AMENDMENT OF SOLICITATION/MODIFICATION OF CONTRACT			1. CONTRACT ID CODE N/A		PAGE OF PAGES 1 70
6 ICCLIED BY	3. EFFECTIVE DATE SEP. 03, 2004	4. REQUISITION/PURCHAS N/A		SPEC. 1	NO. (If applicable) NO. 1406
DEPARTMENT OF THE ARMY U.S. ARMY ENGINEER DISTRICT, SACR SACRAMENTO, CALIFORNIA 95814-2922	7. ADMINISTERED BY (If other than Item 6) DEPARTMENT OF THE ARMY U.S. ARMY ENGINEER DISTRICT, SACRAMENTO SACRAMENTO, CALIFORNIA 95814-2922

14. DESCRIPTION OF AMENDMENT/MODIFICATION (O. California Army National Guard (CAARNG) Readiness Center Lancaster, California	0 - 2	s, including solicitation/contrac	t subject matter where fe	asible.)	
2 Encl.					
 Revised Pages: List of Drawing and Specing 02230-1,02260-1,02300-1,02300-3,0274 09310-3,09511-4,09511-5,09680-1,09912 Revised Drawings: T000, C101, C102, C103 S302,S303,S306,S410,S412,S413,S414,S414 	1-8,02751-6,033000-4, 2-2,10200-3,10505-6,1 ,C110,A004,A005,A2	03470-3,05310-1,0811 5515-6,15839-2,15839 12,S100,S101,S110,S1	(0-3,08331-5,084) 9-3,15900-3,15900 111,S211,S220,S2	11-4,09260- 0-5	3,09310-2,
Except as provided herein, all terms and conditions of th and effect.	e document referenced in Ite	m 9A or 10A, as heretofore	changed, remain

√4 t=8"

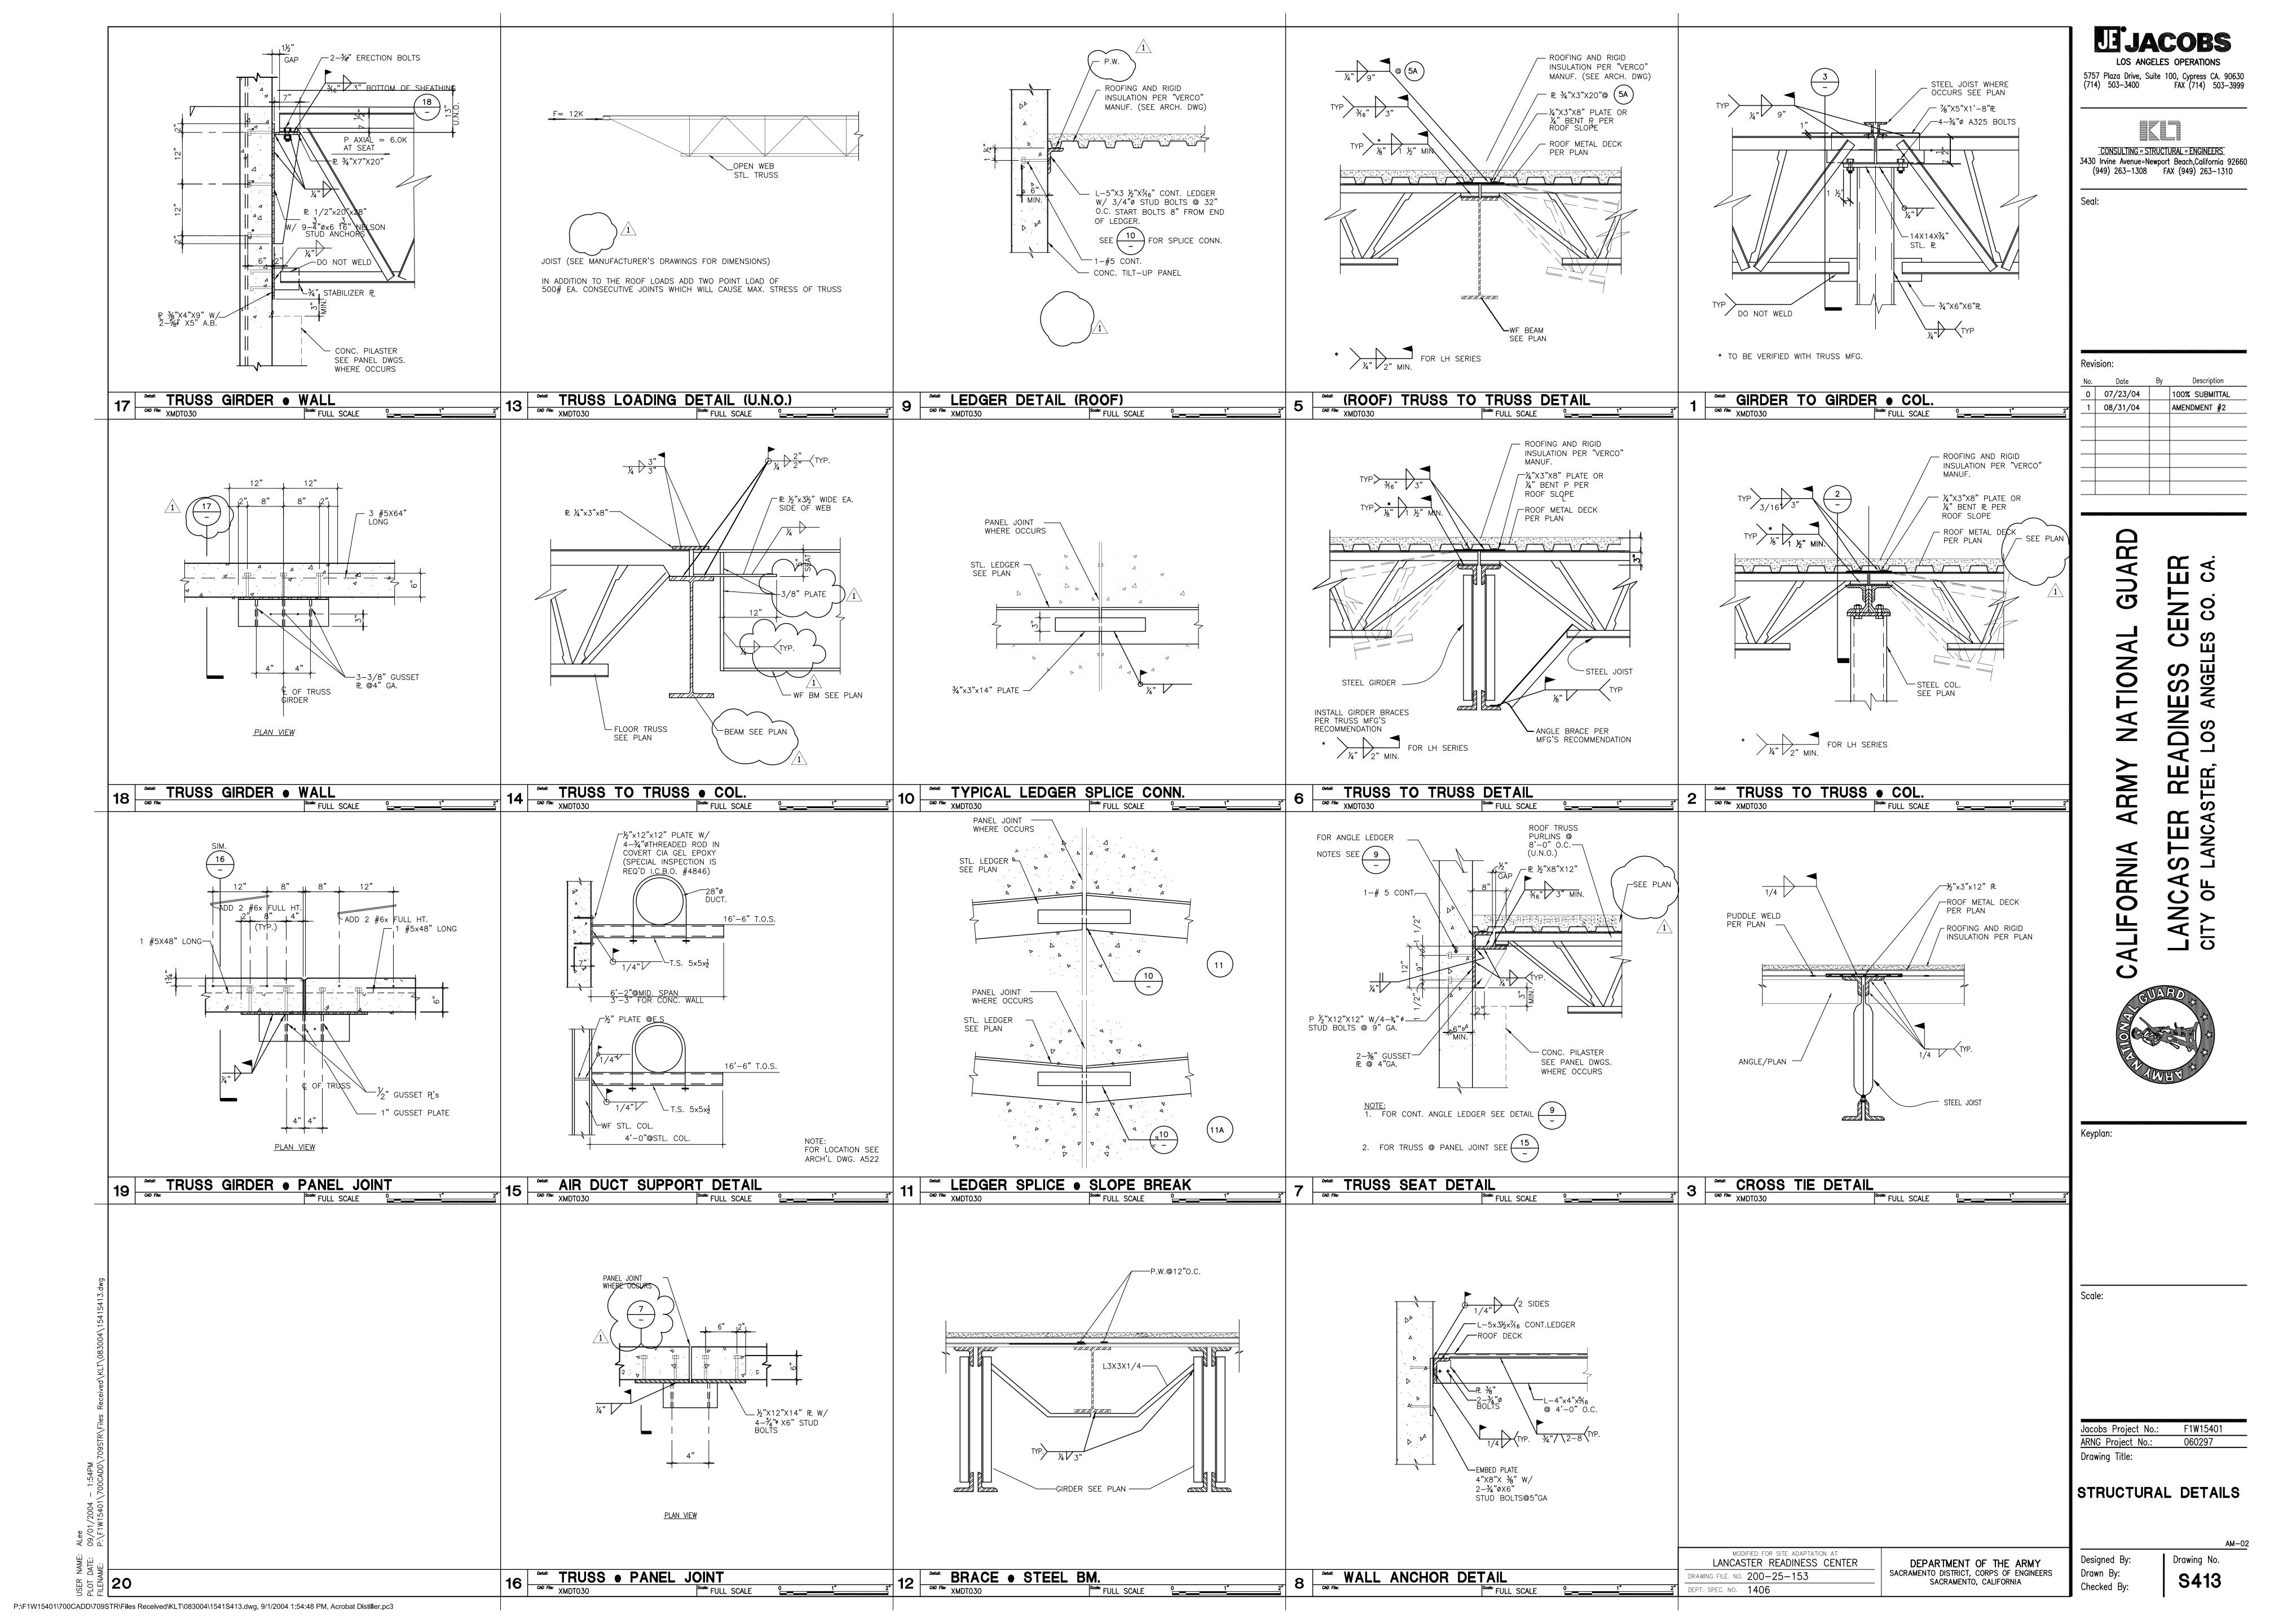
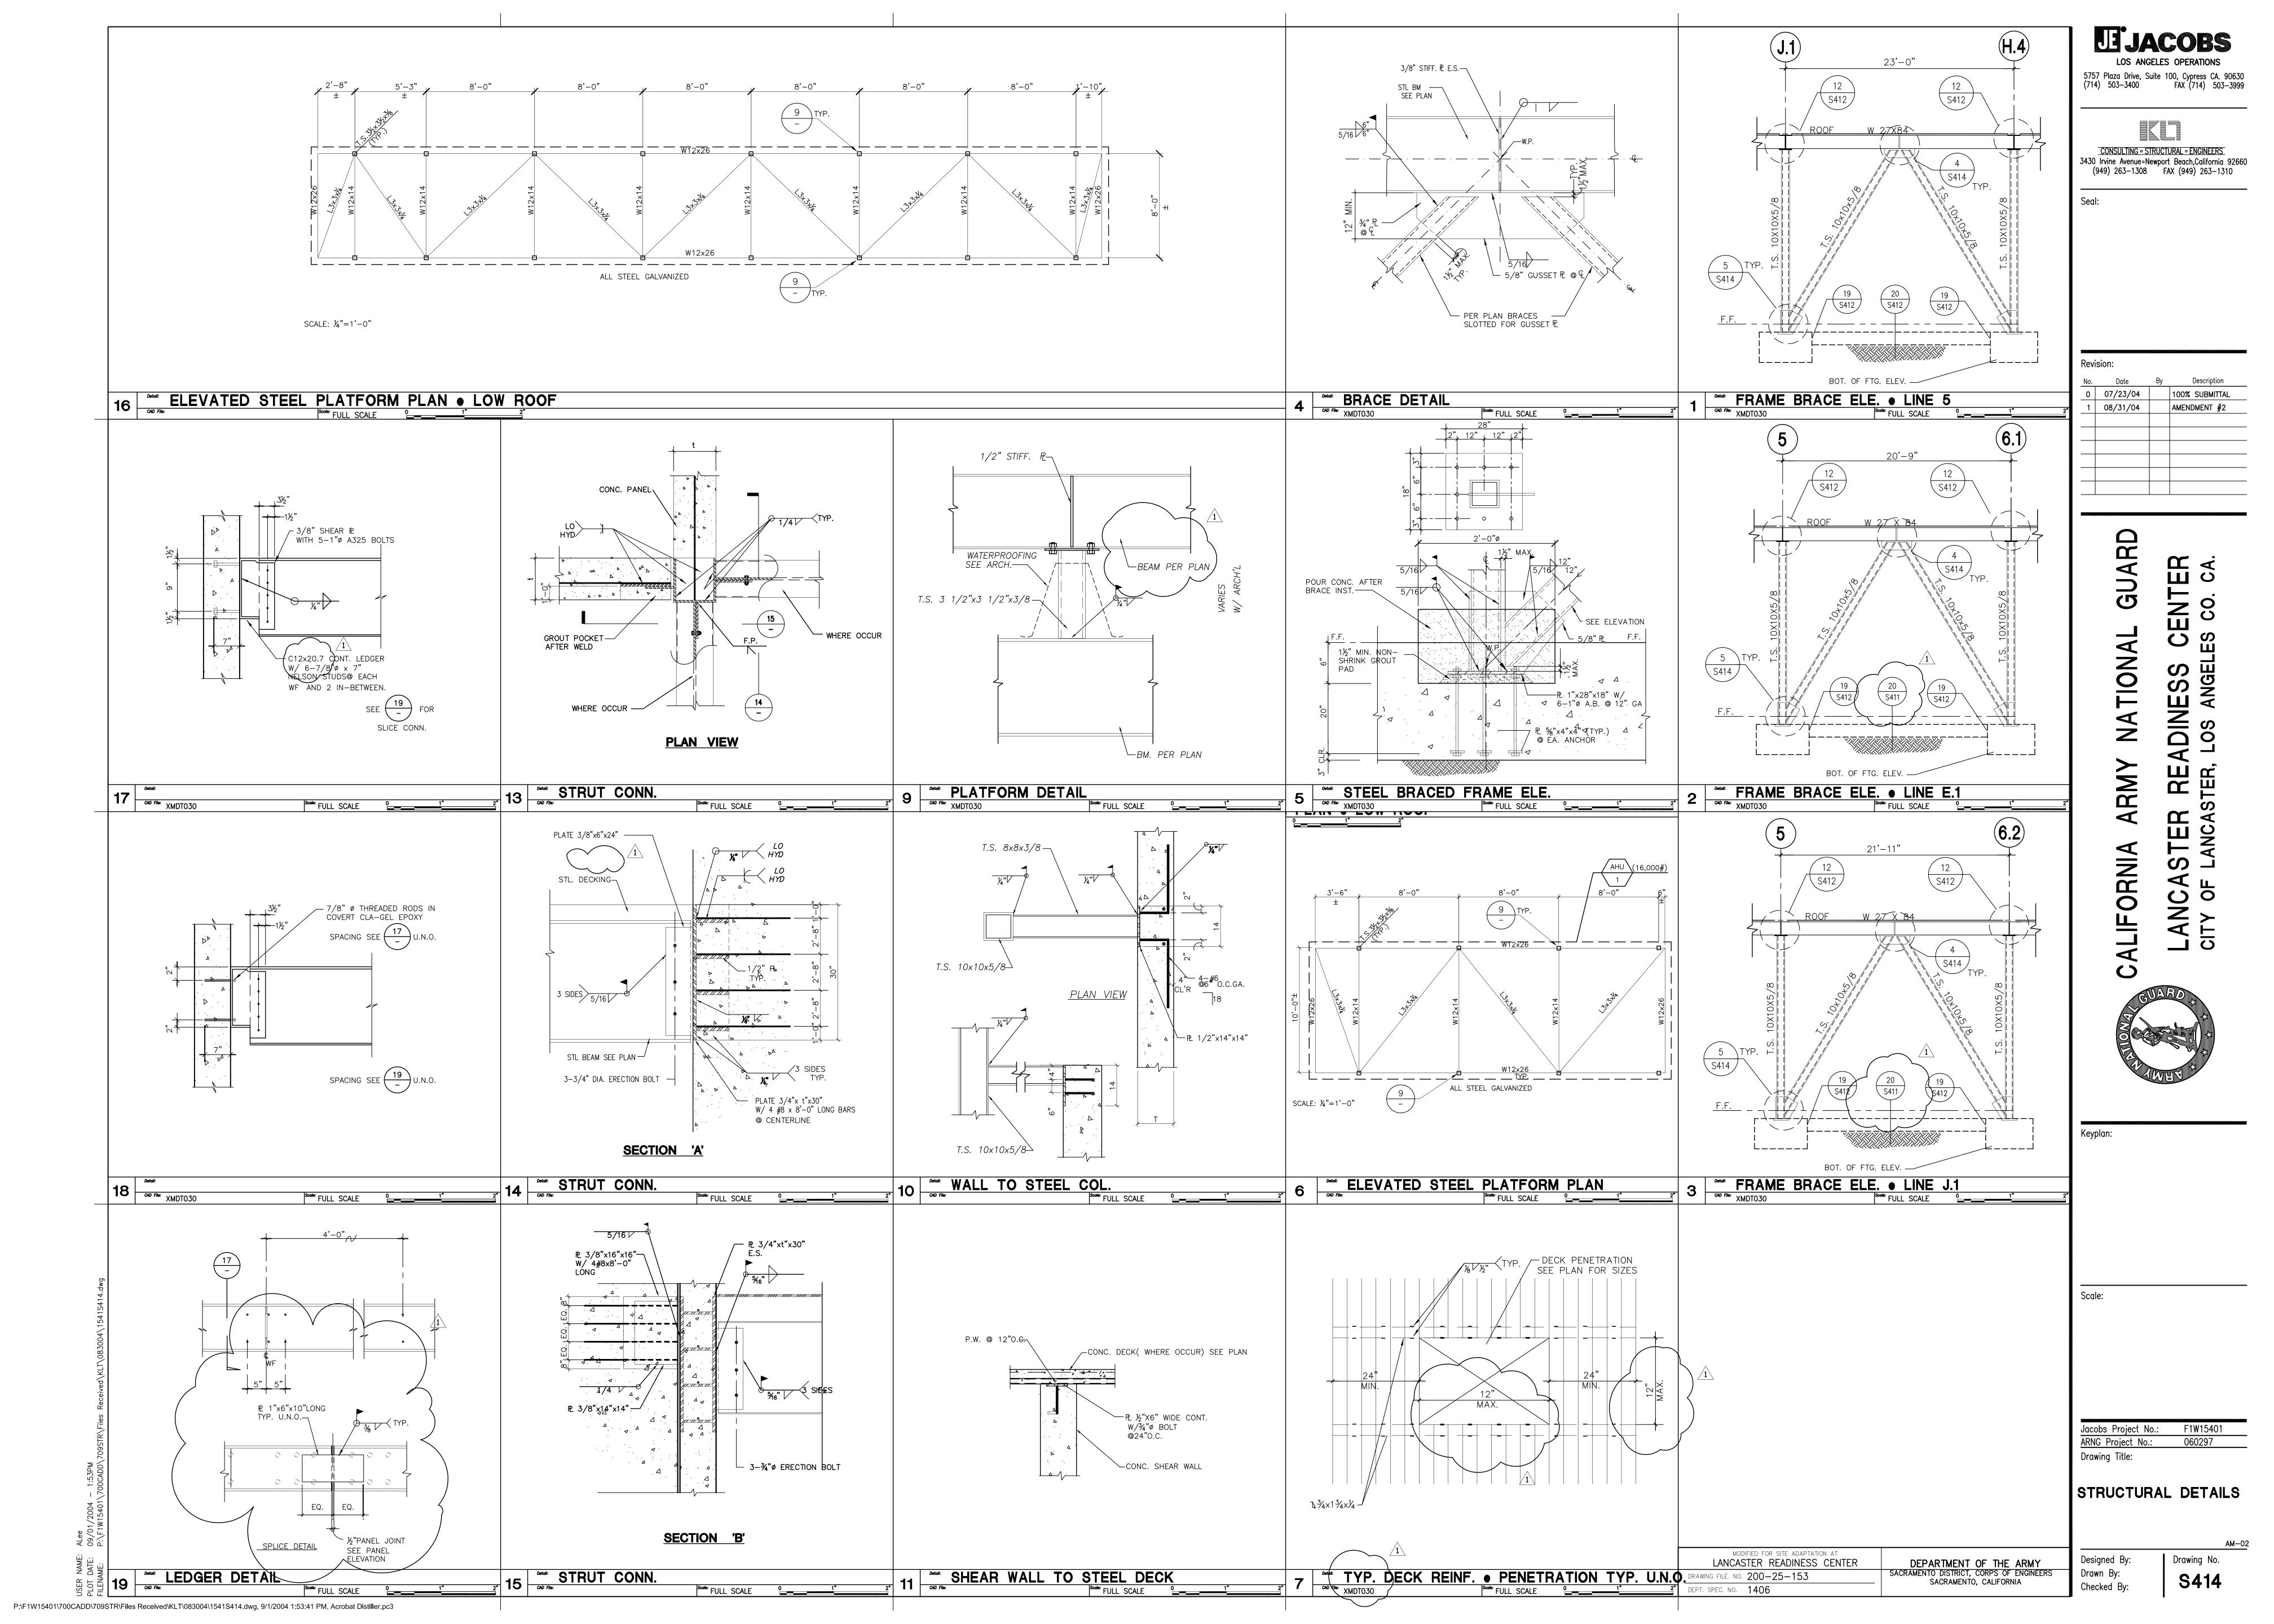
S302	Wall Panel Elevation	Revised a detail callout
S303	Wall Panel Elevation	Revised two detail callouts
S306	Wall Panel Elevation	Revised panel dimensions
S410	Structural Details	Added dimension on detail #3; Revised detail callouts in detail #16
S412	Structural Details	Detail #3 added weld symbol & revised note
S413	Structural Details	Detail #2 and 7 added note; Detail #9 and 13 deleted note; Detail #14 revised note; Detail #16 & 18 revised detail callout
S414	Structural Details	Detail #2 and 3 revised detail callout; Detail #7 added dimension; Detail #9 and 17 revised note; Detail #14 deleted note; Revised detail #19
S416	Stairs 1, 2, & Roof Access Enclosed Plans & Sections	Revised note in detail # 3 and 5, revised enlarged plan # 8, 9, 10, 11 and 12
03300	Cast-In-Place Concrete	Revised Part 2.2 (F.2)
03470	Tilt-up precast concrete	Revised Part 2.1 (B)
05310	Steel Deck	Add Part 1.2 (2)
